# TS 4-20 06036 1.6L ENG POOR IDLE/PERFORMANCE - HIGH TENSION WIRES

TECHNICAL SERVICE BULLETIN

### HIGH TENSION WIRE SET

Model(s): 1994-95 Suzuki Sidekick  
Section Title: Engine  
Division: Automotive  
Category: Technical  
Bulletin No.: TS 4-20 06036  
Date: June 3, 1996

Fig. 1: Spark Plug Wire - Old Style & New Style

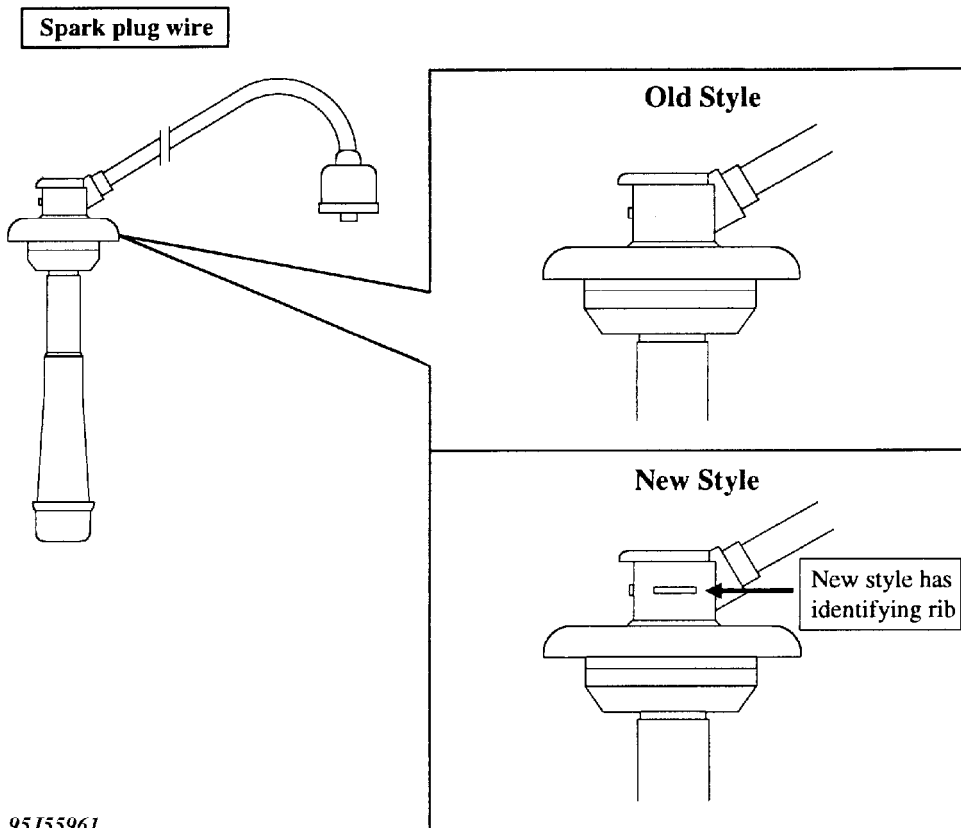
Spark plug high tension wires deteriorated.

1. Raise hood and secure with hood prop rod.
2. Look at the side of the spark plug boot top. See Fig. 1.
3. If one or more of the spark plug high tension wires are the old style, proceed to the SERVICE PROCEDURE.

Replace the old style spark plug high tension wire set with the new style.

Description	Part Number	Qty.
High Tension Wire Set	33705-57B21	1
